Re: SPECIAL EXCEPTION REQUEST  
1712 WINCHESTER ROAD  
ANNAPOLIS, MD 21409

Re: VARIANCE REQUEST  
1714 WINCHESTER ROAD  
ANNAPOLIS, MD 21409

PELLICANO PROPERTY COTTAGE  
SPECIAL EXCEPTION PLAN  
1714 WINCHESTER ROAD  
ANNAPOLIS, MD 21409  
WINCHESTER

- 2024-0156-V; Pellicano (AA 2024-24): We note that the Zoning Pre-File comments state that the applicant must show that the use has not ceased for the last three years. However, in order to meet the Critical Area grandfathering provisions that would allow for the legal nonconforming accessory dwelling unit to be reconstructed within the Critical Area Buffer and on lands designated as a Resource Conservation Area, the County must verify and determine that the use has been in continuous use since the Critical Area local program inception and has not been abandoned for more than one year in that time. If the County verifies the use has been in continuous use and has not been abandoned for more than one year, and the Administrative Hearing Officer finds that each and every one of the Critical Area variance standards have been met, then appropriate mitigation is required.

**DRAINAGE AREAS TO ESD FACILITIES**  
SCALE: 1" = 20'

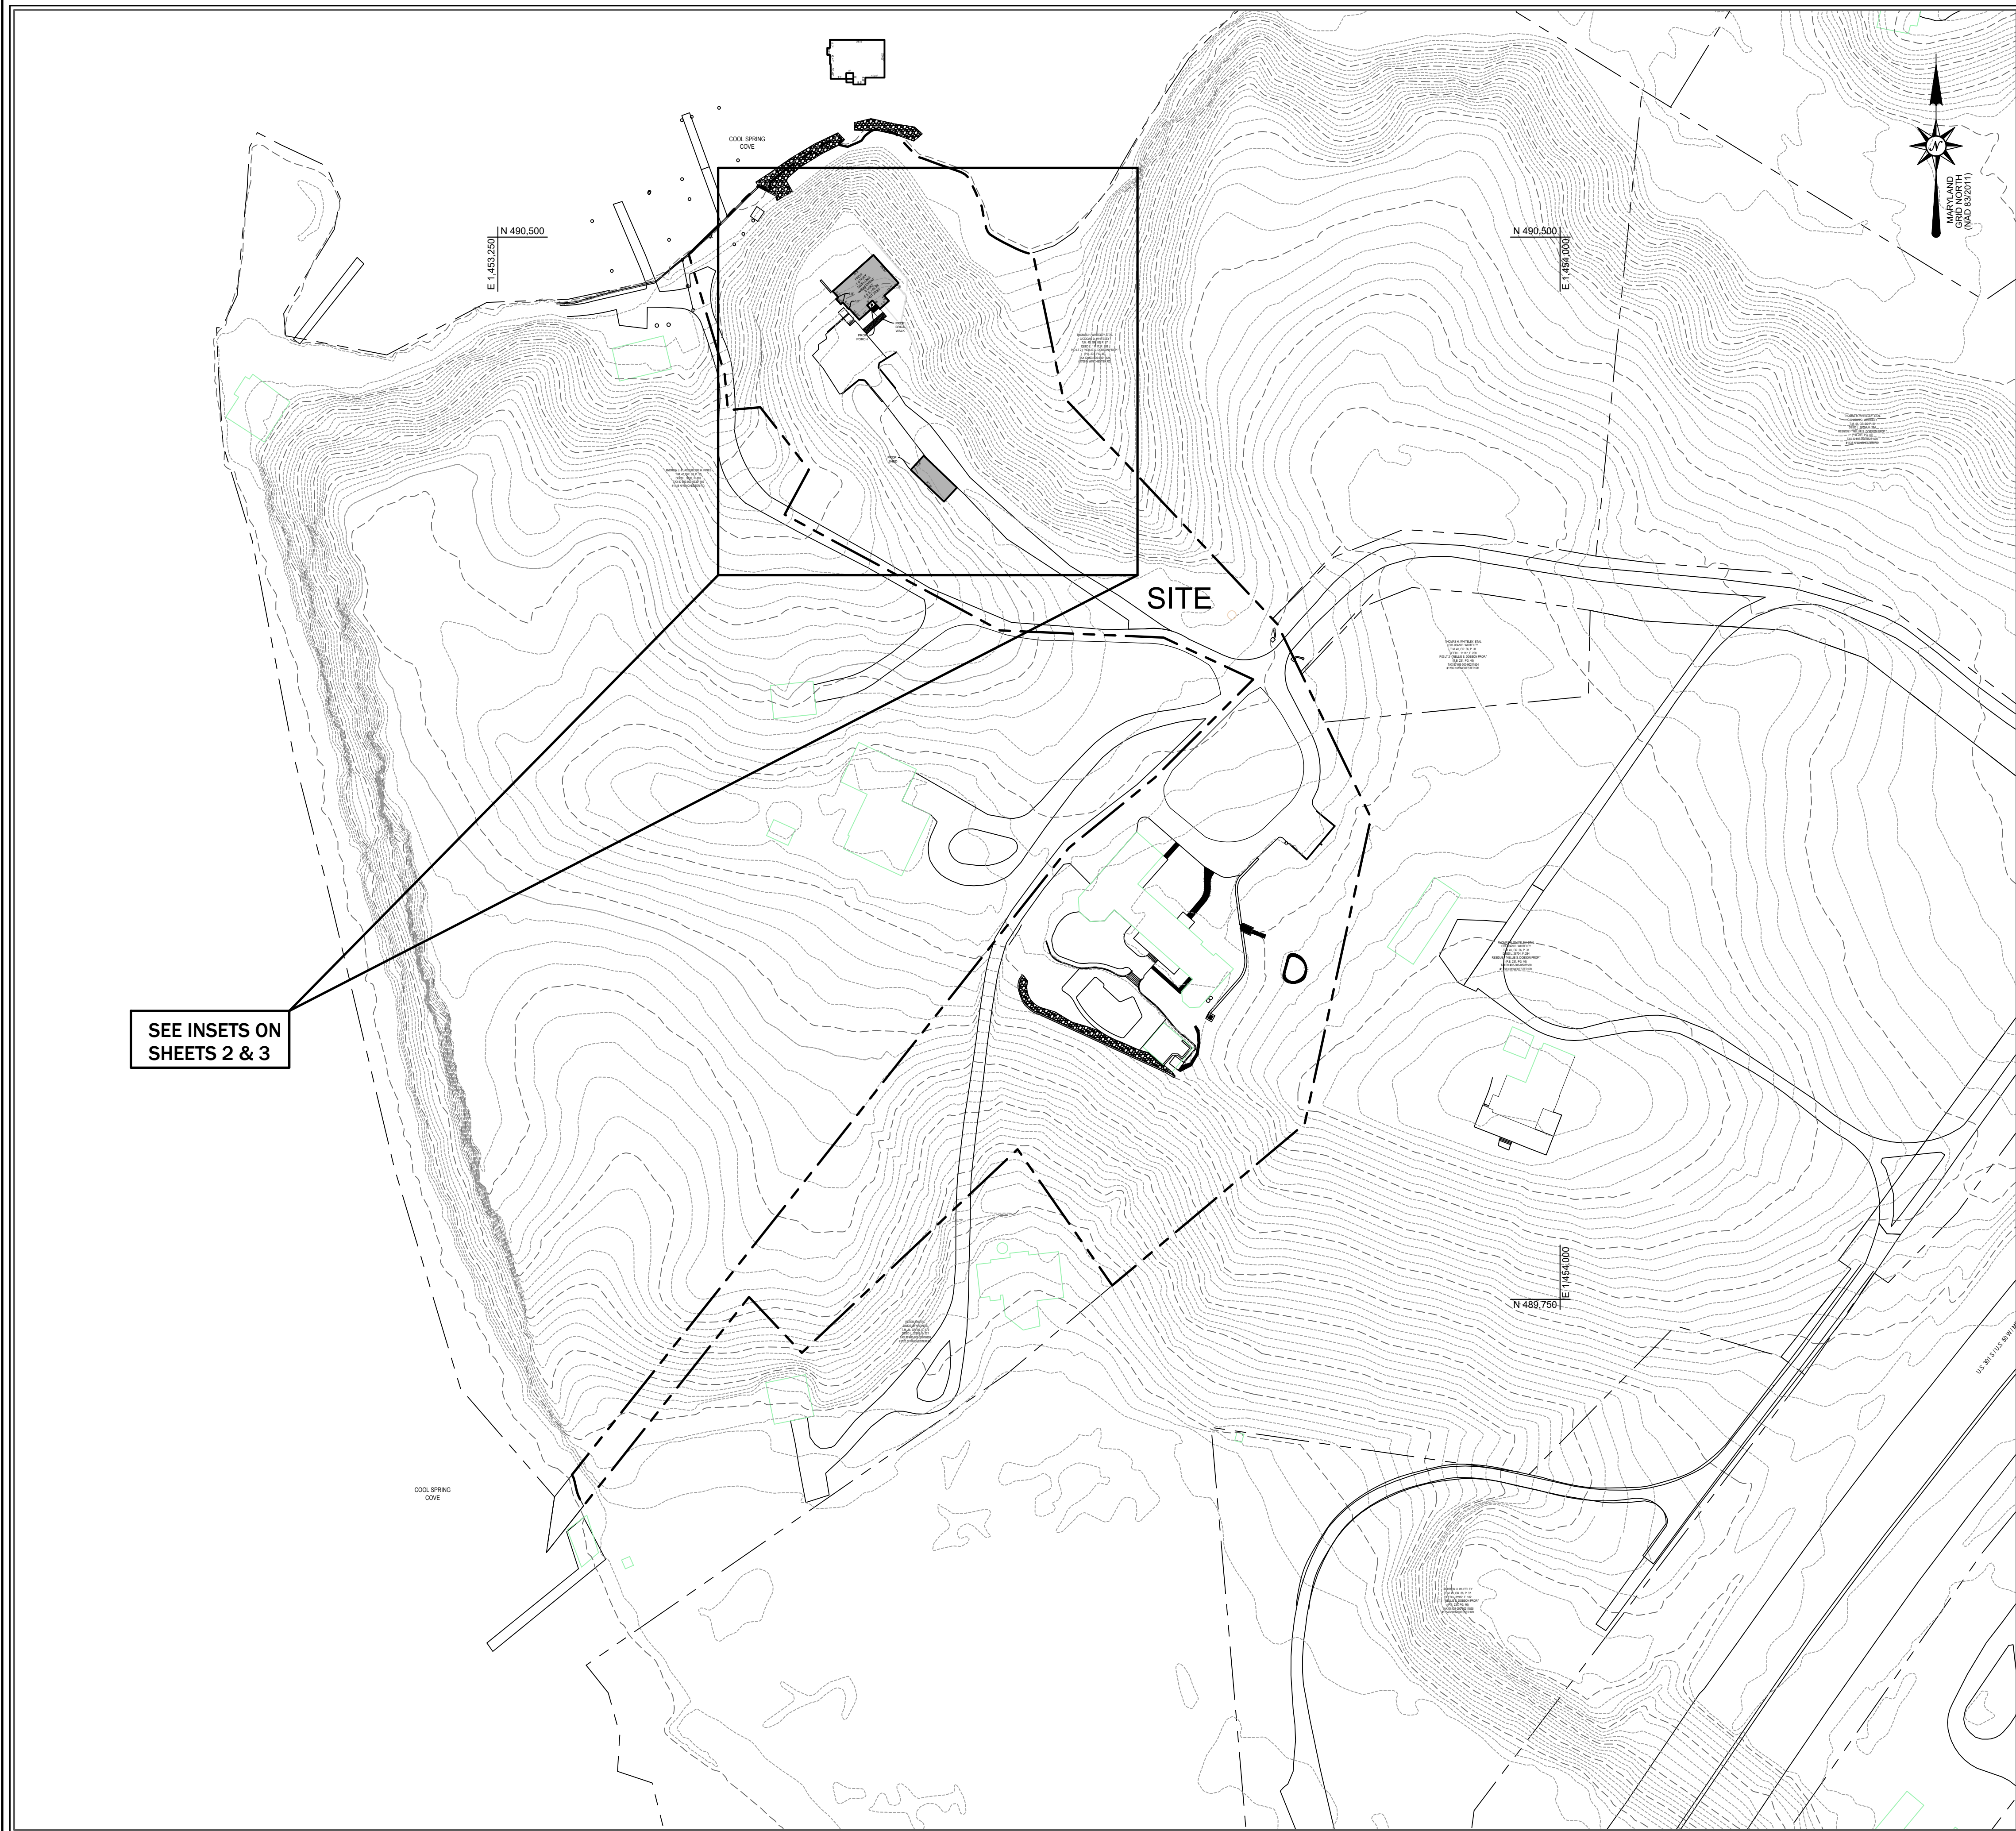
- 1- Two types of LOD calculations need to be performed. The overall LOD, which will determine if a grading plan is required or not and the LOD for determining the level of SWM treatment. The LOD for SWM treatment may subtract the slope stabilization work and the septic work. Also, please confirm that no new impervious surface is being created and the drain pattern will not be changed. This work on will be considered a modification to an existing Single family dwelling for an accessory structure. The slope stabilization work may be considered acceptable SWM mitigation for the modification work. This needs to be documented in a SWM report for the project.

LEVEL 1 PLAN  
SCALE: 1/8"=1'-0" DATE: SEP10, 2014

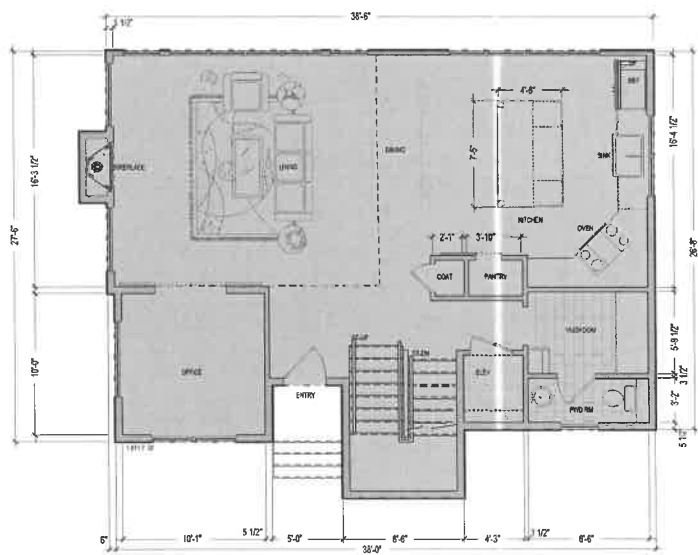
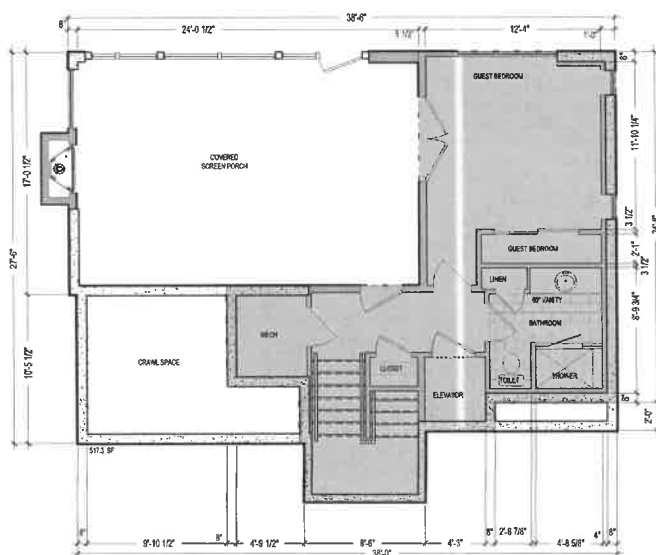
- (1) Provide evidence that the nonconforming use has not ceased for the last three years.
- (2) Include the height of both the existing dwelling and the proposed dwelling on the Administrative Site Plan.
- (3) The applicants are reminded that, in order for the Administrative Hearing Officer to grant approval of the special exception, the proposal must address and meet all of the applicable standards provided under Sections 18-15-103 and 18-16-304. The Letter of Explanation should address each of those standards and provide adequate justification.

EXISTING AREAS:

LVL 0: 548.95 SF  
LVL 1: 1168.25 SF  
TOTAL: 1652.6

W30% EXPANSION ALLOWABLE  
(1652.6 X 1.3) = 2,148.3
